**THE
NATIONAL
BOARD**
OF BOILER AND
PRESSURE VESSEL
INSPECTORS

**NATIONAL BOARD
SUBCOMMITTEE
PRESSURE RELIEF DEVICES**

MINUTES

Meeting of January 16, 2019
San Antonio, TX

C = Constant for vapor that is a function of Specific Heats $k=c_p/c_v$ (See Figure x.x.x.d).
Note: Where k is not known, $k=1.001$

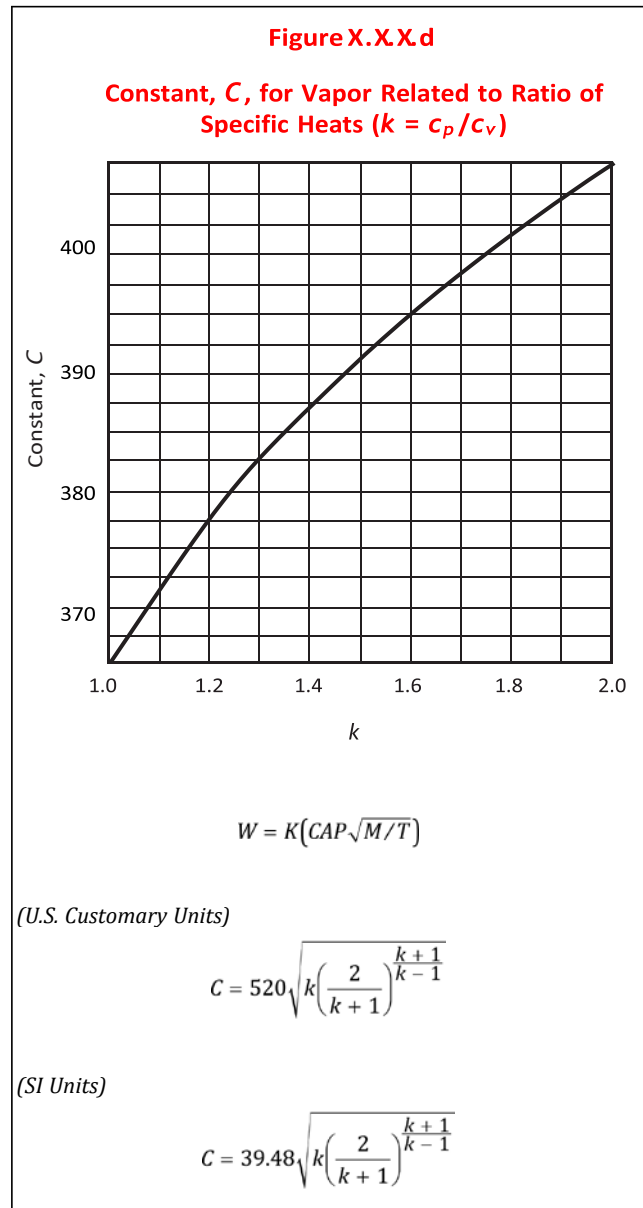
f) Pressure relief valve discharge capacity shall be determined from the following equation:

$$W = CKAP \sqrt{(M/T)}$$
